Nelson City Council

Maitai Dam
Intermediate Dam Safety Review
2015

Tonkin & Taylor

May 2015

PLOT 4 - STANDPIPE PIEZOMETERS (01 APRIL 2012 TO 31 MARCH 2015)

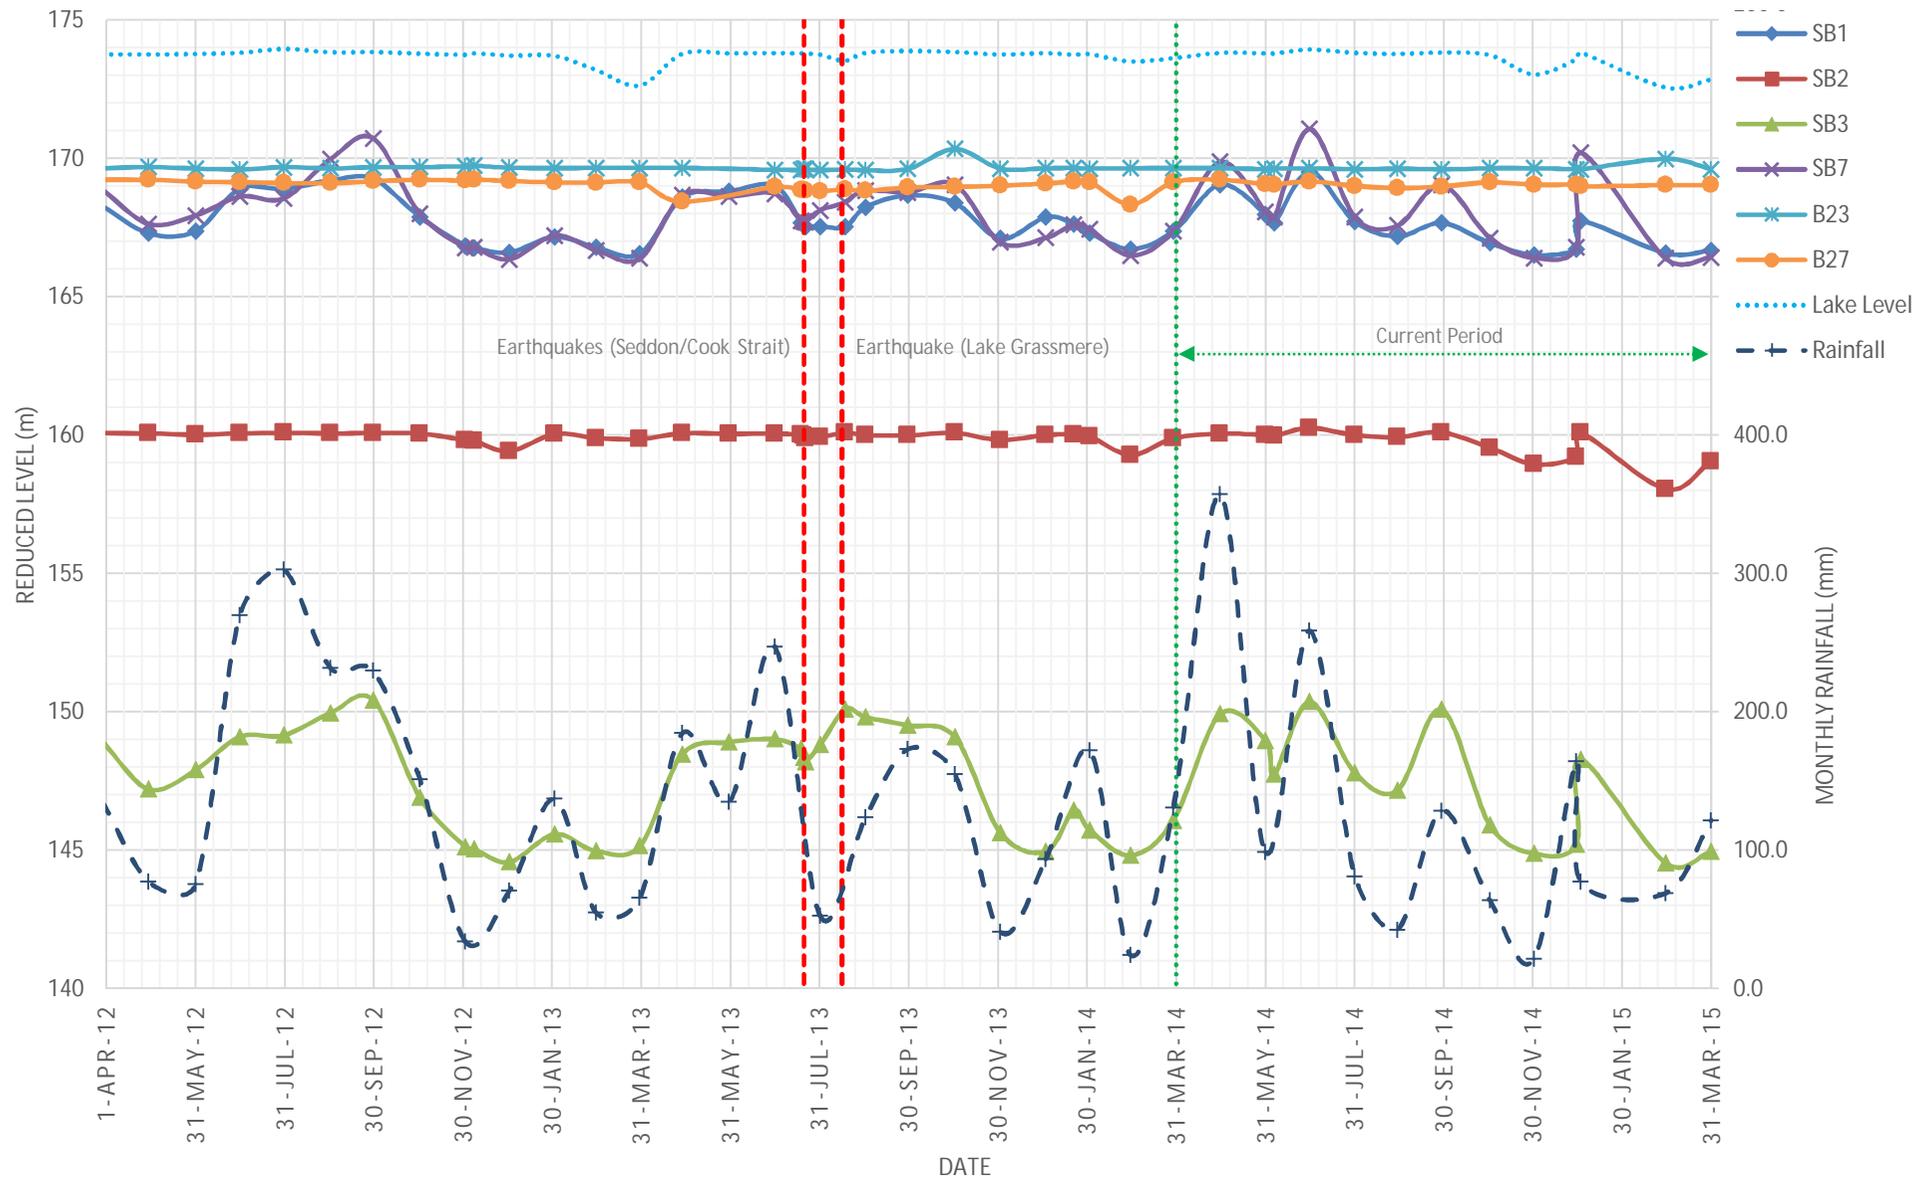
A plot of the standpipe results are shown on Plot 4 in Appendix B. All standpipes continue to give generally consistent readings. SB2 appears to approximately mirror reservoir level. The peaks and troughs in the readings for SB1, SB3 and SB7 appear to follow the peaks and troughs of the monthly rainfall.

PLOT 5 - SEEPAGE (01 APRIL 2012 TO 31 MARCH 2015)

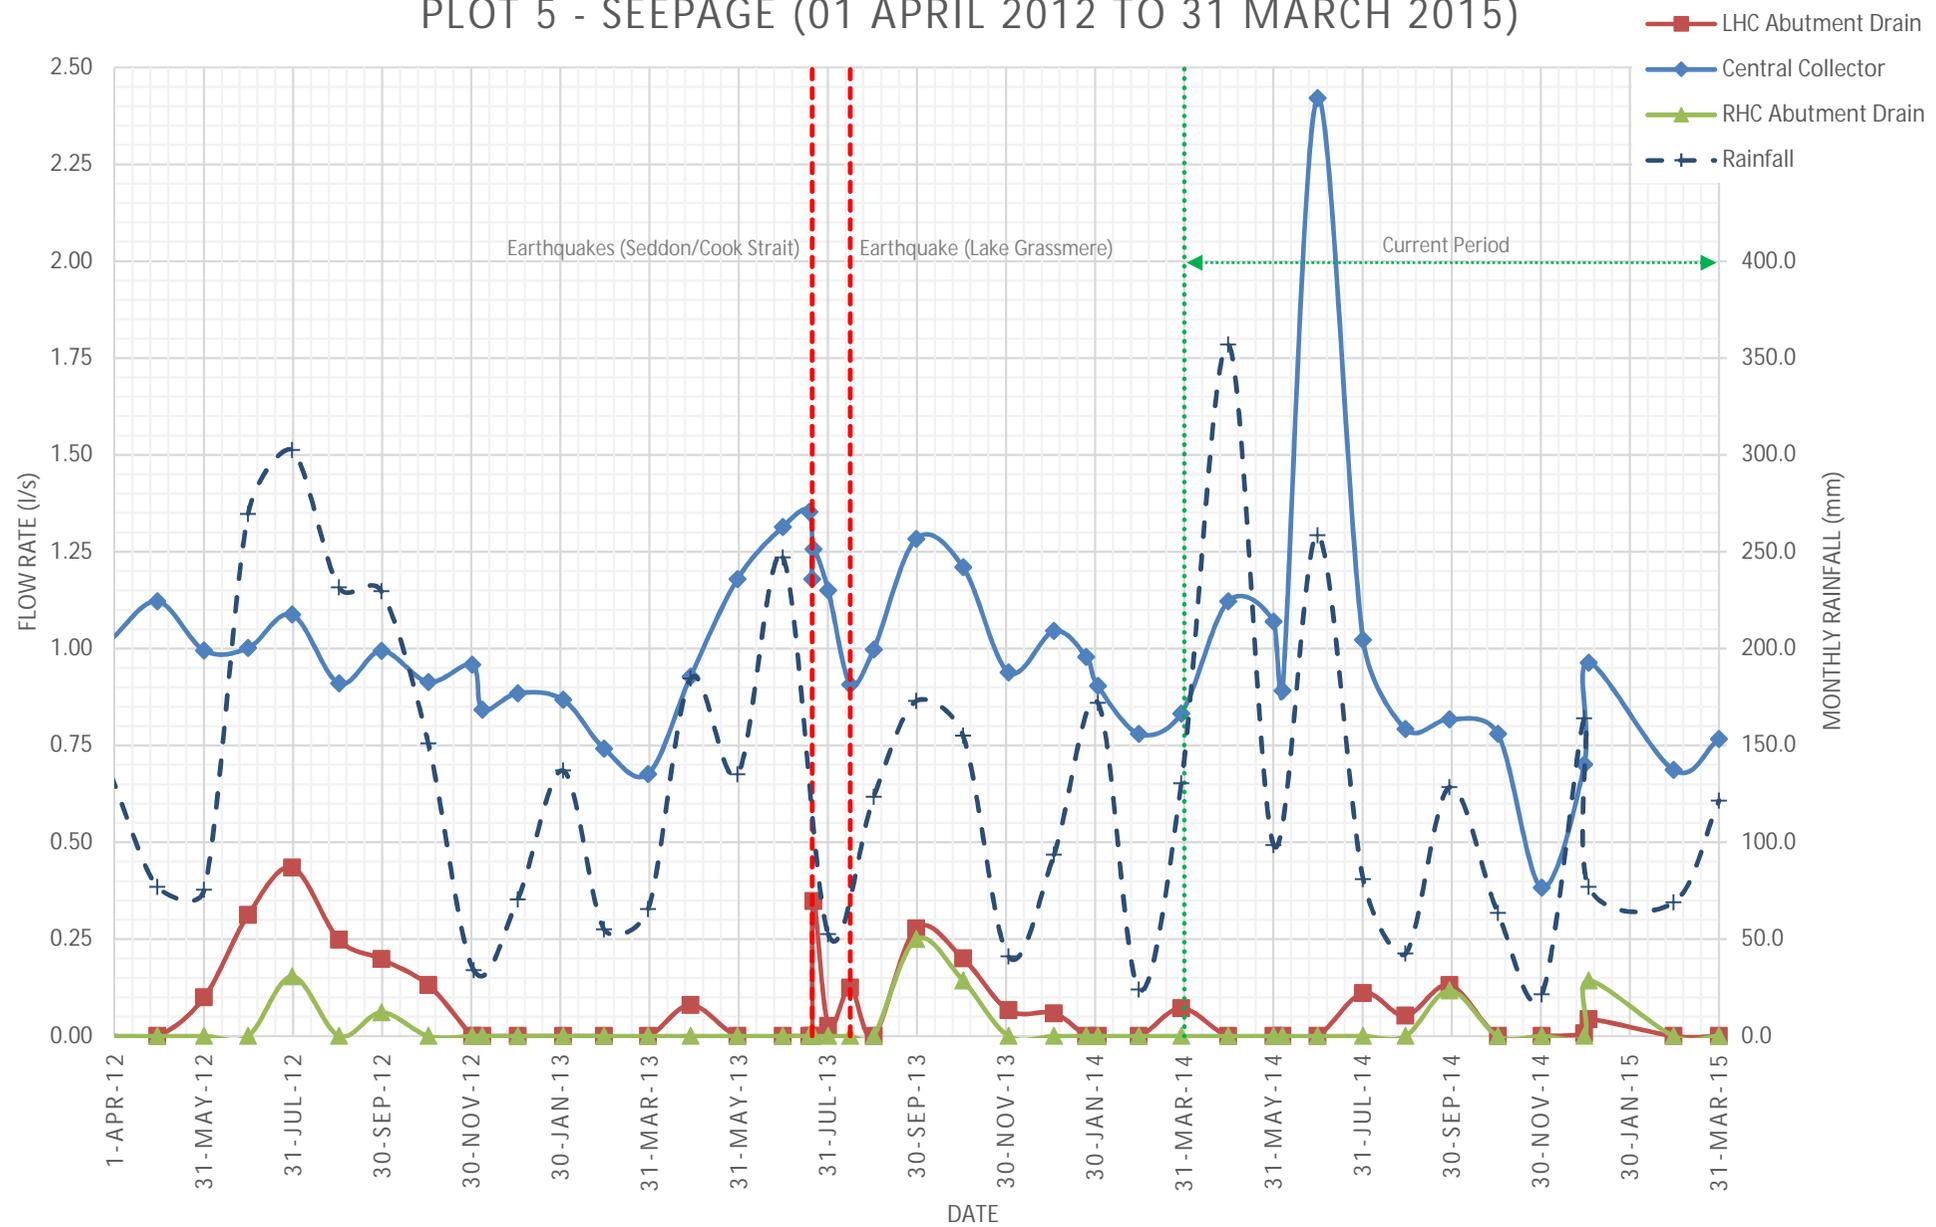
The following particular observations are made for the period ending 31 March 2015). Plot 5 Appendix B, includes seepage and rainfall data. Instrument locations are provided in Appendix A.

The relevant drains are the: Central Collector (CC) drain, Seepage Collector Outlet, Left Abutment Contact drain and the Right Abutment Contact drain. The responses of all the drains are summarised as follows:

- Central Collector: CC is the seepage collector outlet flow minus the left and right abutment contact drains. The maximum reading is acceptably within the overall range experienced since commissioning. Flows were reasonably consistent over the monitoring period except for a spike in July. The July reading of 2.4 l/s was considerably higher than the next highest reading for the last 5 years (1.4 l/s). It is noted that the high seepage flows coincided with a high monthly rainfall record. However, with the available data it is not possible to confirm if there was heavy rainfall shortly before the data reading (Refer DSR2015-4 below). We note that the data spike is well less than the trigger level of 14 l/s. Measured flows ranged between 0.38 l/s and 2.42 l/s (1.12 l/s, excluding the July spike) during the period.

- Seepage collector outlet (not shown on Plot 5): Flows between 0.38 l/s and 2.42 l/s (1.15 l/s, excluding July spike) are within the range since commissioning. All recorded flows continue to be well within the trigger limit of 14 l/s for the seepage collector drain.
- Left abutment contact drain (LHC): Readings have been relatively consistent over the last period with flows of up to 0.13 l/s recorded (well within the acceptable limit of 2 l/s).
- Right abutment contact drain (RHC): Readings have been relatively consistent over the last period with flows of up to 0.14 l/s recorded. These measured flows ("RHC" on Plot 5) are within the previous range of records and are less than the maximum acceptable flow of 2 l/s.

DSR 2015 - 4 Collect and provide daily rainfall data
